Lloyd's Register of Shipping.

Ship's Name M.V. SEASILVER

Memorandum of alterations reported since ship was surveyed for assignment of Load Lines
in

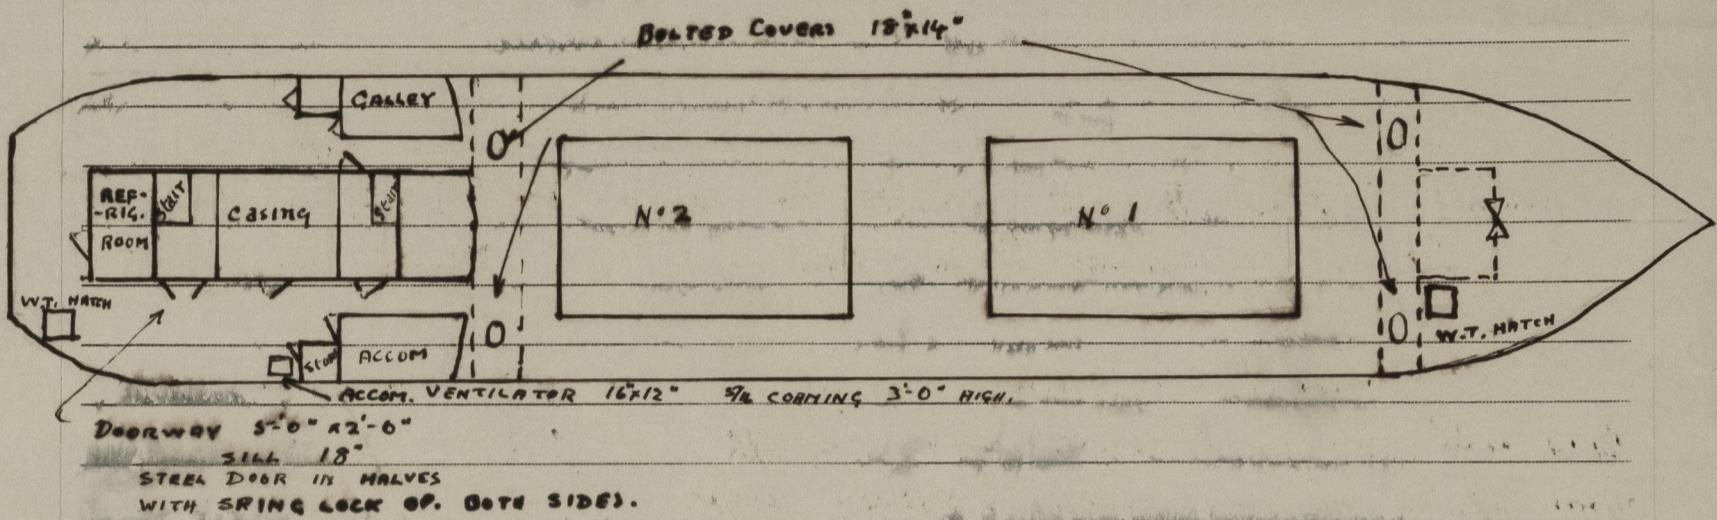
copper bands fitted at each end of tween deck and after end of hold to water seal hold when carrying petroleum in steel containers.

Store moved to upper F.P. Opening at after end of chain locker sealed and access given at fo'd end.

W.T. hatches to old store removed and openings sealed with riveted steel plate. Starbd hatch now fitted to upper F.P. and old manhole closed with riveted steel plate.

Refrigerator room fitted at after end of machinery casing. Ventilator with fan fitted on starbd side to supply trunk ventilation to accommodation.

The 18-14" marshals shown
in oil card. are in order.
